# Product Change Notification

## 113644 - 00

**Change Notification #:** 113644 - 00  
**Change Title:** Intel® Server System R2308IP4LHPC  
PCN 113644-00, Product Design,  
Update the Power Distribution Board and  
Add a KCC label  
**Date of Publication:** February 13, 2015

Figure-2: Location of Capacitors C11 and C13

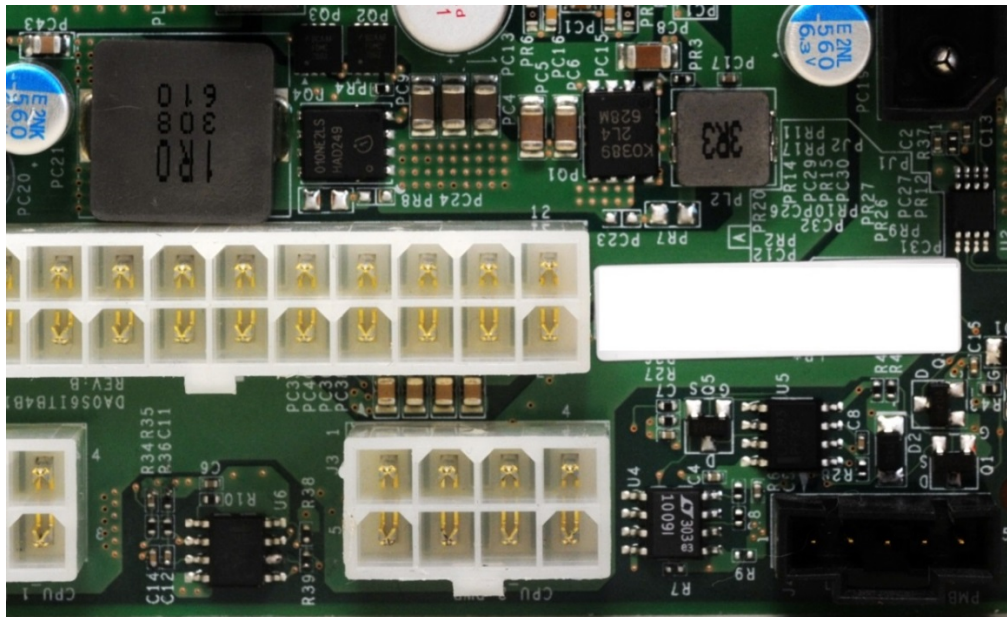
2. Increase the two capacitor values of C11 and C13 on the Spare Power Distribution Board (PDB) FBP750PDB from 0.1 $\mu$ F to 2.2 $\mu$ F to extend the duration of the Over Current Protection (OCP) circuit from 0.6ms to 8.0ms. This change prevents the potential system shutdown event triggered by the violation of the 240VA regulation of the OCP circuit. See Figure-2 below.
